STAFF REPORT

(One Step Combined Preliminary/Final Plat)

CASE NUMBER: S/D 96-82 - AUBURN HILLS COMMERCIAL 2ND ADDITION

VICINITY MAP:

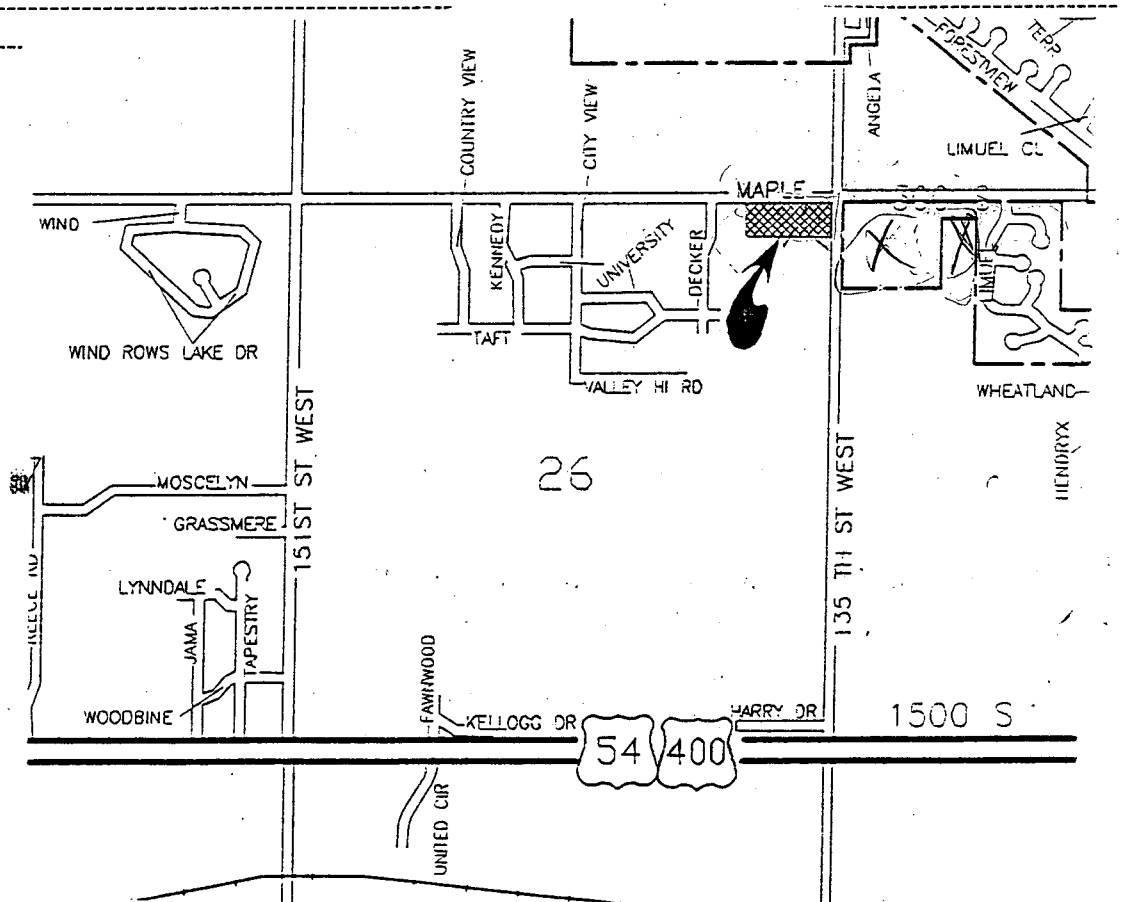
SITE SIZE: 7.35 Acres *Drainage SS to S*

*SS agreement w/ County?
W in maple to be a 24"*

- A. As required by City Engineering, the applicant shall guarantee the extension of sanitary sewer to the lots being platted, and the extension of Municipal water adjacent to the site.
- B. The applicant shall guarantee any drainage improvements required by the platting of this property.
- C. As noted by CUP, DP-225, the applicant shall guarantee; an acceleration-deceleration lane around the corner of the intersection, adjacent to this site and permanent paving of 135th Street West along the site's frontage to that street.

- E. Since this site has apparently already been annexed to the City of Wichita, County Commission approval is unnecessary and the County Commission signature shall be deleted from the final plat tracing. The plat's title shall also note the Addition is to Wichita.

- F. On the final plat tracing, the following corrections shall be made to the plattor's text.
 - 1. The description of Reserve A shall be properly stated; presently a sentence or portion of a sentence is missing. The ownership and maintenance responsibilities shall also be stated.

- 2. The text shall state that it is dedicating access controls to the City of Wichita, with the openings approved by the City Engineer.
 - 3. Since a wall is allowed in Reserve A, it shall be noted that utilities may cross this Reserve.

- H. On the final plat tracing, the note indicating the site is subject to additional building setbacks per a CUP, shall be corrected to indicate DP-225 and not DP-219.
